# Work Order ID 113394

## DART SERVICE INSTRUCTION

TO AMEND INSTALLATION INSTRUCTIONS D206-558 REV. C OR EARLIER  
AND INSTRUCTIONS FOR CONTINUED AIRWORTHINESS ICA-D206-558 REV. 0

REF: CANADIAN STC SH92-17  
REF: FAA STC SH1031NE

**FIGURE 1 - BRACKET INSTALLATION**

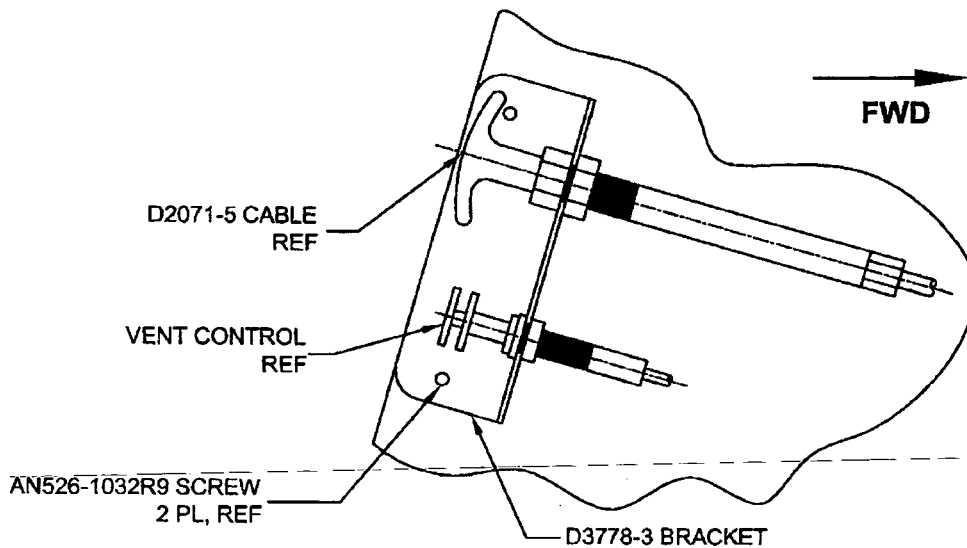
THE D3778-1 BRACKET HAS ALSO BEEN REPLACED WITH THE D3778-3 BRACKET FOR BETTER PILOT COMFORT.

INSTALL THE D3778-3 BRACKET AS DESCRIBED BELOW:

- 1) IF INSTALLED, REMOVE THE EXISTING VENT CONTROL BRACKET AND REMOVE THE VENT CONTROL.
- 2) PICKING UP ON EXISTING ANCHOR NUTS, INSTALL THE D3778-3 BRACKET USING AN526-1032R9 SCREWS.
- 3) INSTALL THE VENT CONTROL IN THE LOWERSLOT. INSTALL THE D2071-5 CABLE IN THE UPPER SLOT.
